Type Coffee Vending Machine	Model 9100 - 95	N° T.I. 05 - 2019	
Serial Number 90511159	Subject "O - RING" CHANGE FOR PIN OF CAPILLARY THERMOSTAT	ISSUED FOR (X)	Action Information <input checked="" type="checkbox"/>

Boiler assembly

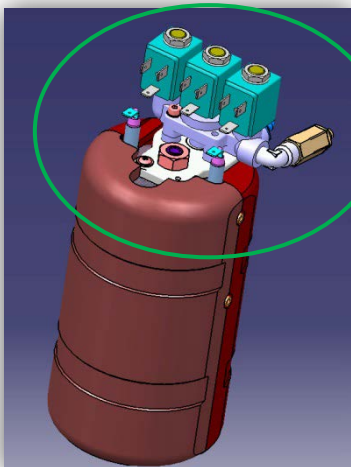
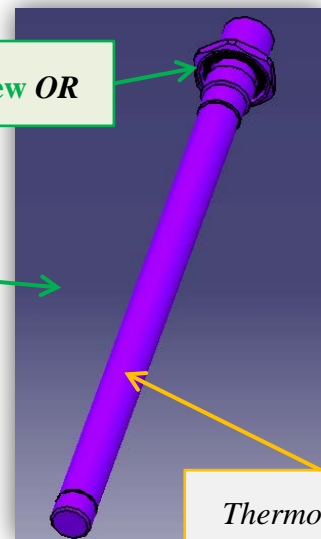
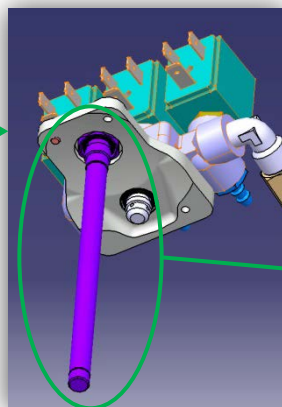
To avoid any hydraulic leakage

The **OR** for the **pin** of boiler capillary protector has been replaced by a new one.

New **OR** gasket - 1,78X9,25 Spare code:
257077 sap:55114775

Pre - modific. **OR** gasket - 1,78X7,65 Spare
code: **094594**

New **OR**

Thermostat **pin**

The pre - modification **OR** (spare: **094594**) is still available and it is used for the *solenoid valve assembly*
